Lackagh-Knockdoe Solar Action Group

Correspondence · Letter from a local resident

Re: Planning Application Ref. 2661567 — Blackthorn Solar Farm

Request for urgent Board consideration and a formal school submission

Figure 1. Proximity of proposed development site to Scoil Naomh Bhríde

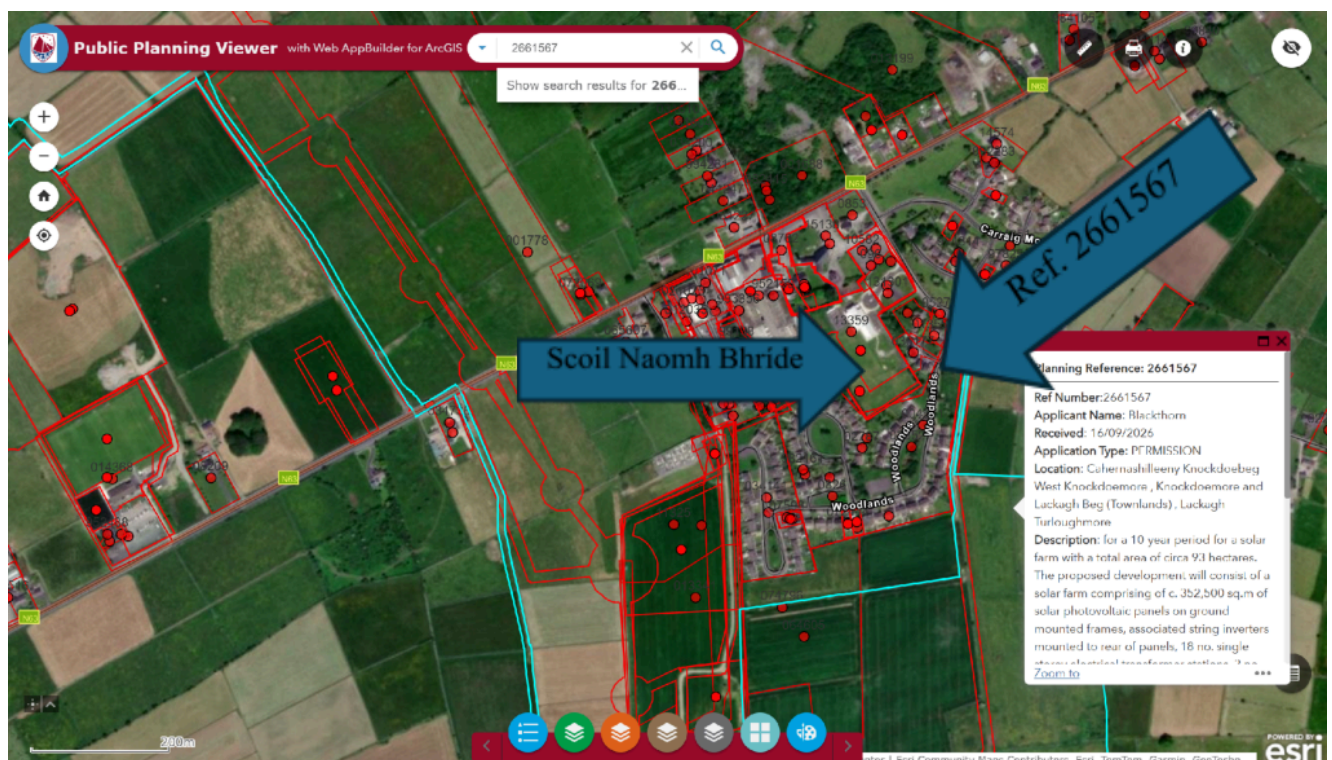
The application documents refer to a construction programme extending over approximately 12 to 18 months overall. The southern parcel, which is served from the L21332 adjacent to the school, is stated to require approximately 56 weeks of construction activity. Figure 1 shows the proximity of the development site to Scoil Naomh Bhríde.

The Construction Traffic Management Plan identifies the L21332 as providing access to Parcel 2. Scoil Naomh Bhríde is located on that local road.

The CTMP states that the L21332 has a carriageway width of approximately 3.5 metres. Local measurements indicate that the road width varies substantially along the route and narrows significantly beyond the school on the approach to the proposed site entrance. That constrained section has direct implications for the school because traffic approaching it from the R354 direction may wait, queue or reverse on the approach road outside or near the school.
